DEVELOPMENT APPLICATION ASSESSMENT REPORT

Application Number:	DA2022/1619
----------------------------	-------------

Responsible Officer:	Dean Pattalis
Land to be developed (Address):	Lot 20 DP 28663, 65 Dolphin Crescent AVALON BEACH NSW 2107
Proposed Development:	Alterations and additions to a dwelling house including a swimming pool
Zoning:	C4 Environmental Living
Development Permissible:	Yes
Existing Use Rights:	No
Consent Authority:	Northern Beaches Council
Land and Environment Court Action:	No
Owner:	Jaedho Two Pty Limited
Applicant:	Jaedho Two Pty Limited

Figure 1: area above 8.5m height plane shown as per the black dotted lines

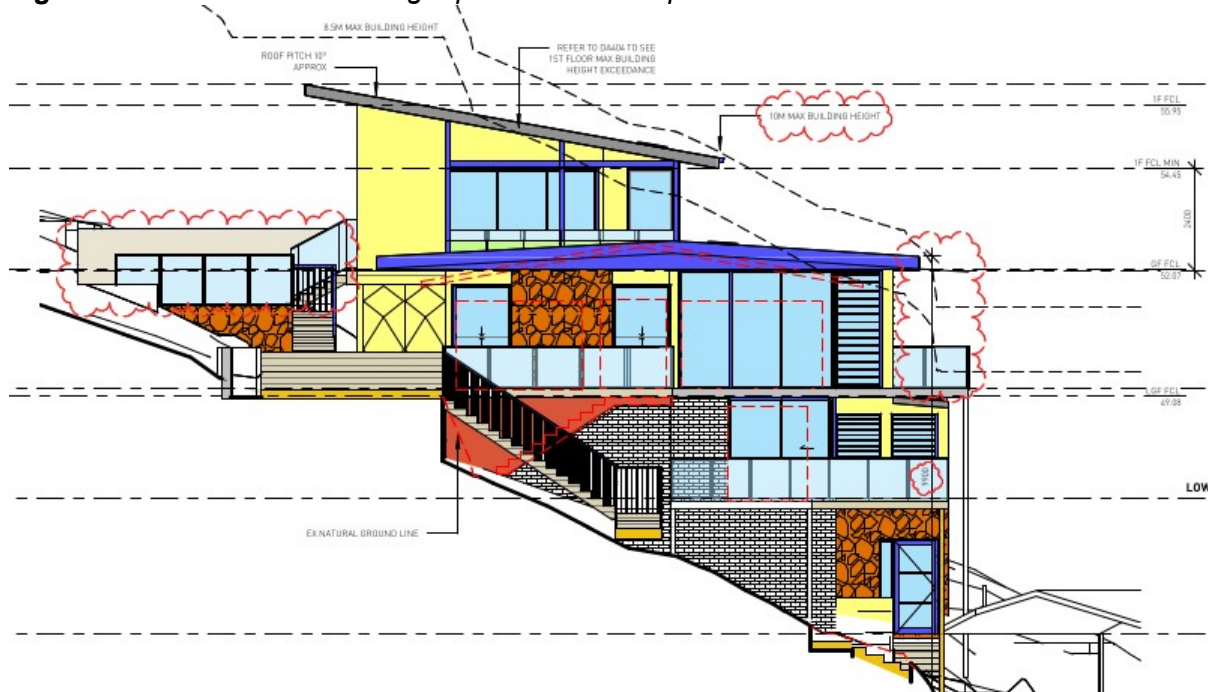
The area of the dwelling house located above the 8.5m height limit is primarily confined to a portion of the roofline and eave overhang, including a small area of the external wall of the building at the first floor and ground floor levels. The majority of the building remains within the 8.5m limit. Figure 1 below depicts the area of the building that protrudes above the 8.5m height plane.

As demonstrated above, the area located above the 8.5m height plane is minor and acceptable.

Figure 2: Eastern envelope encroachment shaded in red

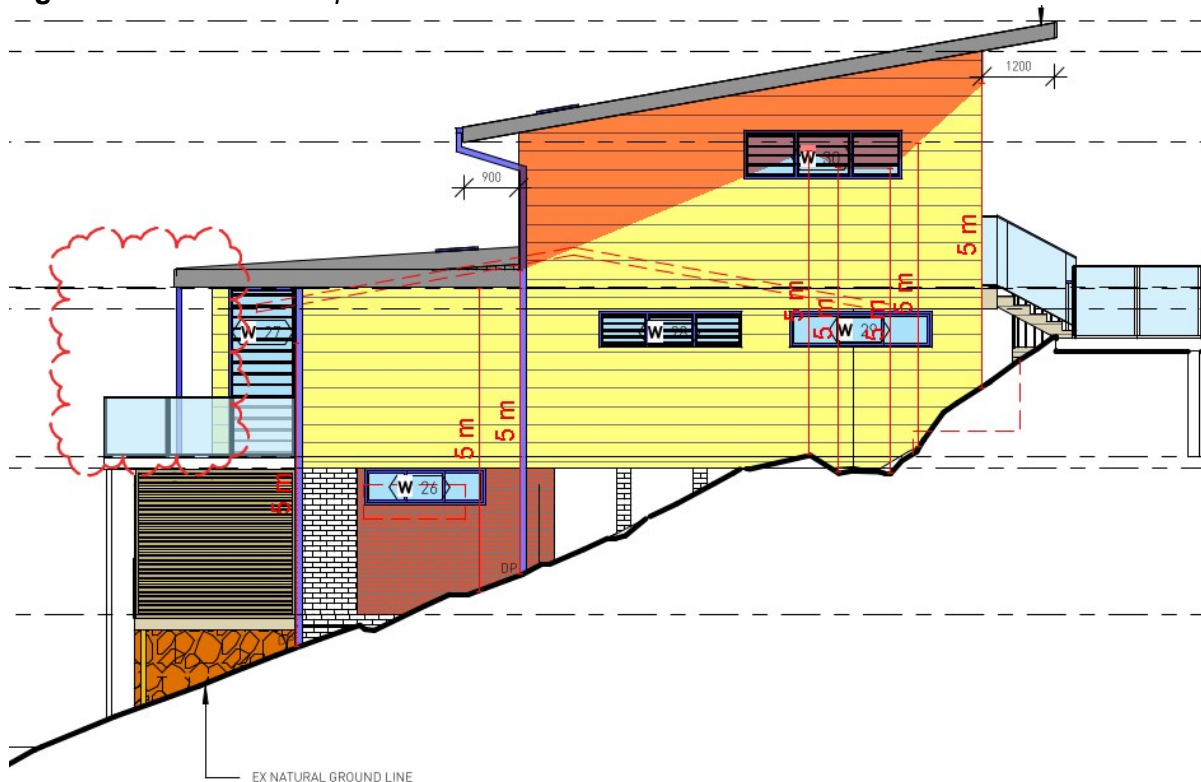
The proposed development comprises a maximum variation to the numerical control on the eastern elevation of 2.08m (41.6%). The western elevation of the dwelling complies with the control.

The control states that where the building footprint is situated on a slope over 16.7 degrees (ie 30%), variation to this control will be considered on a merits basis.

In light of the above, the proposal is considered reasonable and should be supported on merit.
